Access Compliance Report Public Rights-of-Way (Island Curb Cuts)

Main Street: ROSSMOOR_WAY		Cross Street: ROSSMOOR_WAY		Location:	W
ADA ID: CCRK211217124925	Curb Cut Type: MedianRefuge2	Initial Pass/Fail: Fail	Overall Compliance: No	Severity Score:	6.25

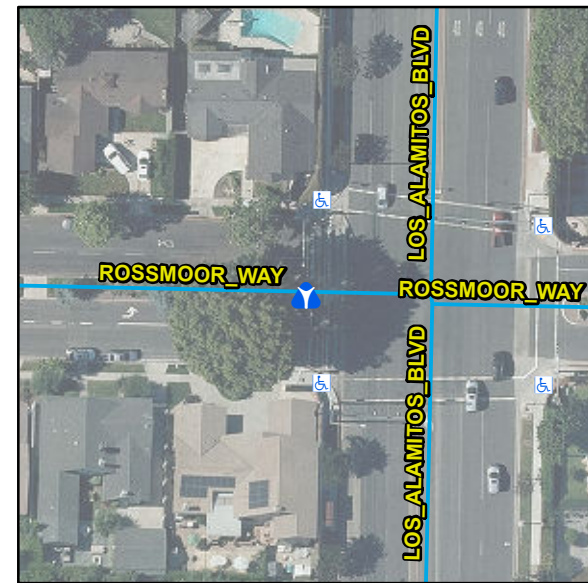
Compliance	Description	Data	Compliance	Description	Data
Yes	Refuge 1 Length (In)	66	N/A	Guttter 1 Ponding	N/A
No	Refuge 1 Width (In)	50	Yes	Gutter 1 Lip Ht (In)	0
Yes	Refuge 1 Slope (%)	0.4	N/A	Gutter 1 Slope (%)	N/A
Yes	Refuge 1 Cross Slope (%)	3.6	N/A	Gutter 1 Cross Slope (%)	N/A
N/A	Painted Cross Walk 1	Yes	N/A	DWS 1 Provided	N/A
	Cross Walk 1 Direction	N	N/A	DWS 1 Contrast	N/A
	Cross Walk 1 Width (In)	144	N/A	DWS 1 Length (In)	N/A
Yes	Refuge Inside Cross Walk 1	Yes	N/A	DWS 1 Full Width	N/A
	Road 1 Slope (%)	0.2	N/A	DWS 1 Offset (In)	N/A
	Road 1 Cross Slope (%)	3.6			N/A
Yes	Refuge 2 Length (In)	66	N/A	Guttter 2 Ponding	N/A
No	Refuge 2 Width (In)	50	Yes	Gutter 2 Lip Ht (In)	0
Yes	Refuge 2 Slope (%)	0.4	N/A	Gutter 2 Slope (%)	N/A
Yes	Refuge 2 Cross Slope (%)	3.6	N/A	Gutter 2 Cross Slope (%)	N/A
N/A	Painted Cross Walk 2	Yes	N/A	DWS 2 Provided	N/A
	Cross Walk 2 Direction	S	N/A	DWS 2 Contrast	N/A
	Cross Walk 2 Width (In)	144	N/A	DWS 2 Length (In)	N/A

Remove & Replace Entire Refuge.

R302.3.1, STD 1115
